ORION FANS
10557 Metric Dr
Dallas, TX 75243

Product Change Notification: OD1238 Sealed Sleeve

Issued July 17, 2026

Type of Change: Product Redesign. Electrical, mechanical, and performance specifications impacted, and the Country of Origin has changed.

PREVIOUS SPECIFICATIONS

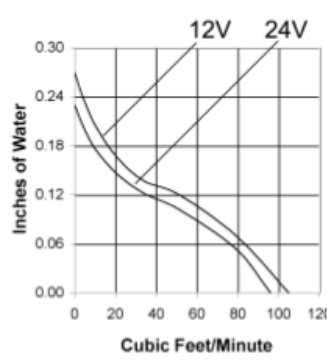
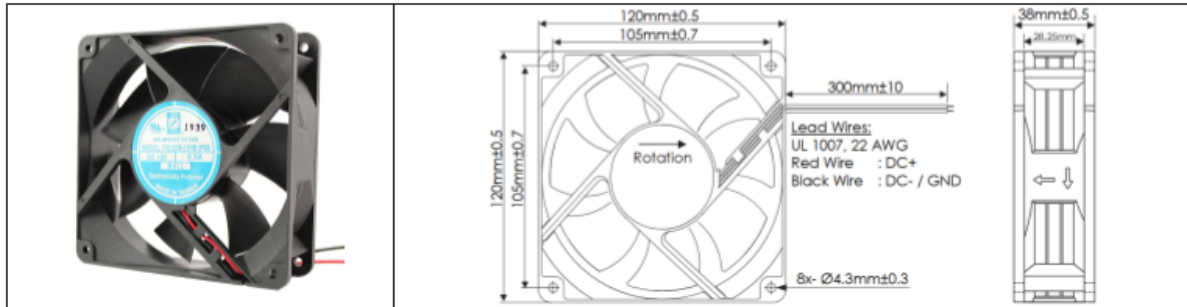
Frame	PBT, UL94 V-0 Plastic	<u>Operating Temperature</u> -10°C ~ +70°C	
Impeller	PBT, UL94 V-0 Plastic	<u>Storage Temperature</u> -20°C ~ +70°C	
Connection	2x Lead Wires, 24 AWG	<u>Life Expectancy</u> 50,000 Hours (L10 at 40°C)	
Motor	Brushless DC, Auto Cutoff, Auto Restart, Polarity Protected, Electronically Protected	<u>Available Options</u> Ball Bearings Tachometer Output Alarm Output PWM Speed Control Input Temperature Speed Control IP Ratings	
Bearing System	Sealed Sleeve	Weight: 0.57 lbs	
Dielectric Strength	500VDC/min, <1mA		
Insulation Resistance	≥10MΩ @ 500 VDC

Part Number	Rated Voltage (Volts DC)	Voltage Range (Volts DC)	Input Power (Max Watts)	Rated Current (Max Amps)	Rated Speed (RPM)	Max Airflow (CFM)	Noise Level (dBA)	Max Static Pressure ("H ₂ O)
OD1238-12HSS	12	9 ~ 13.8	6.0	0.50	2800	105	47	0.27
OD1238-24MSS	24	16 ~ 26	5.5	0.23	2540	96	47	0.23

NEW SPECIFICATIONS

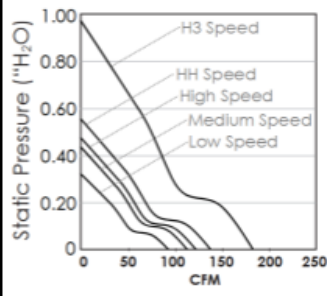
Frame	PBT, UL94 V-0 Plastic	Operating Temperature -20°C ~ +65°C Storage Temperature -25°C ~ +70°C Life Expectancy Ball: 70K Hours (L10 at 40°C) Sleeve: 50K Hours (L10 at 40°C) Available Options Tachometer Output Alarm Output PWM Speed Control Input Temperature Speed Control IP Ratings Weight: 0.57 lbs.	
Impeller	PBT, UL94 V-0 Plastic		
Connection	2x Lead Wires, 22 AWG		
Motor	Brushless DC, Auto Cutoff, Auto Restart, Polarity Protected, Electronically Protected		
Bearing System	Dual Ball Bearings, or Sealed Sleeve		
Dielectric Strength	500VDC/min, <1mA		
Insulation Resistance	≥10MΩ @ 500 VDC

Part Number	Rated Voltage (Volts DC)	Voltage Range (Volts DC)	Input Power (Max Watts)	Rated Current (Max Amps)	Rated Speed (RPM)	Max Airflow (CFM)	Noise Level (dBA)	Max Static Pressure ("H ₂ O)
OD1238-12H3**	12	9 ~ 13.8	17.7	1.43	4190	178.0	54.0	0.977
OD1238-12HH**	12	9 ~ 13.8	10.0	0.90	3195	135.8	48.2	0.558
OD1238-12H**	12	9 ~ 13.8	6.0	0.50	2895	124.1	44.1	0.469
OD1238-12M**	12	9 ~ 13.8	4.8	0.40	2597	114.7	41.3	0.427
OD1238-12L**	12	9 ~ 13.8	2.4	0.20	1975	89.5	35.6	0.316
OD1238-24H3**	24	16 ~ 26	22.1	0.90	4190	178.0	54.0	0.977
OD1238-24HH**	24	16 ~ 26	15.0	0.62	3195	135.8	48.2	0.558
OD1238-24H**	24	16 ~ 26	12.0	0.50	2895	124.1	44.1	0.469
OD1238-24M**	24	16 ~ 26	8.0	0.34	2597	114.7	41.3	0.427
OD1238-24L**	24	16 ~ 26	4.0	0.15	1975	89.5	35.6	0.316
OD1238-48H3**	48	30 ~ 52	20.5	0.41	4190	178.0	54.0	0.977
OD1238-48HH**	48	30 ~ 52	15.0	0.30	3195	135.8	48.2	0.558
OD1238-48H**	48	30 ~ 52	14.0	0.29	2895	124.1	44.1	0.469
